THE SHOPS

SHOPS (No Median)

Shops (No Median)

Proposed (No Median): SE 9th Ave (looking west)

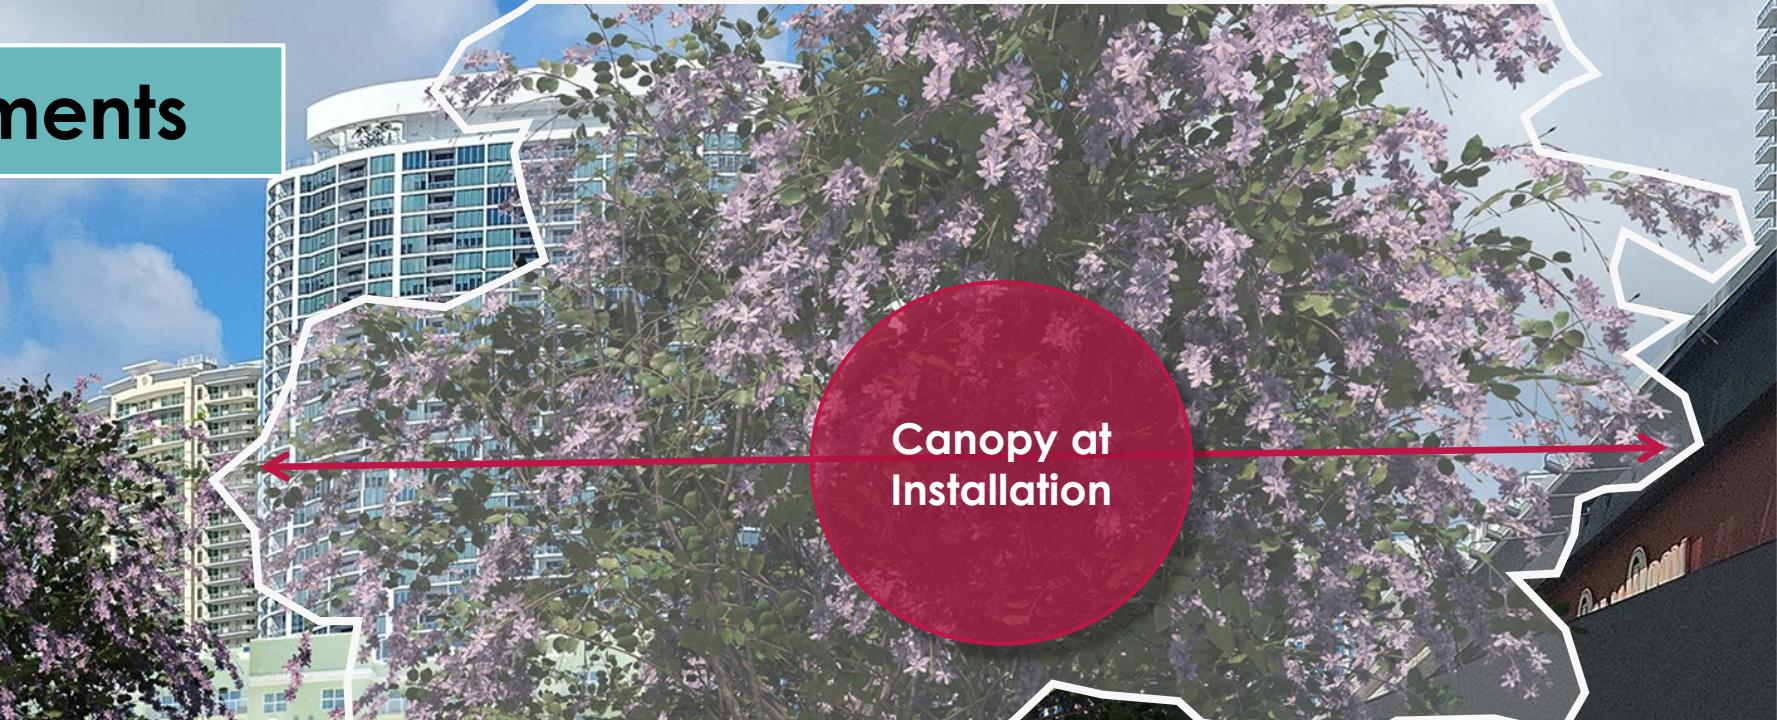
*Pursuant to direction from the City Commission on 1/20/26, the following changes were made:

- Rendering was updated to indicate additional tree canopy coverage and sidewalk shade.
